10 GLOUCESTER GATE, CAMDEN, LONDON, NW1 4HG

APPLICATION FOR VARIATION OF CONDITION 2 FOLLOWING GRANT OF PLANNING PERMISSION (2016/3706/P) – SECTION 73 OF THE TOWN AND COUNTRY PLANNING ACT

APPLICATION FOR VARIATION OF CONDITION 2 FOLLOWING GRANT OF LISTED BUILDING CONSENT (2016/4064/L) - SECTION 19 of PLANNING (LISTED BUILDINGS AND CONSERVATION AREAS) ACT 1990

Second floor of No. 11 Gloucester Gate illustrated in (LPA References: 011/3152/P & 2011/3160/L) Plans

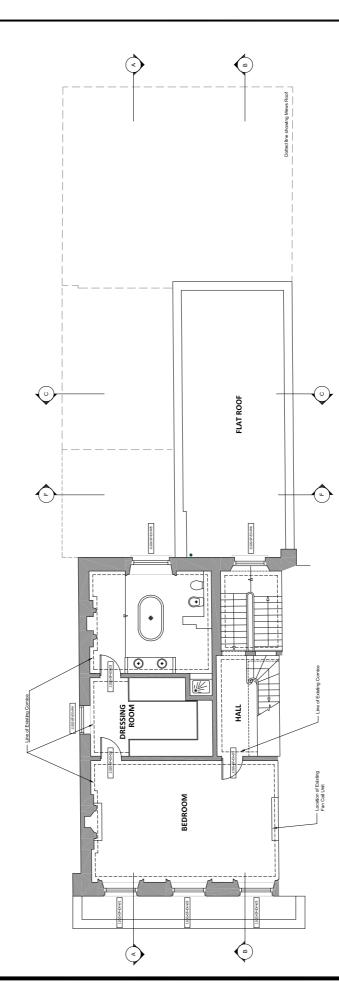
To add further justification, we note that a similar arrangement exists in the neighbouring property at No. 11 Gloucester Gate (Enclosure 1). We have appended the second floor plan which was illustrated as part of the permitted scheme of 2011 (LPA References: 2011/3152/P & 2011/3160/L).
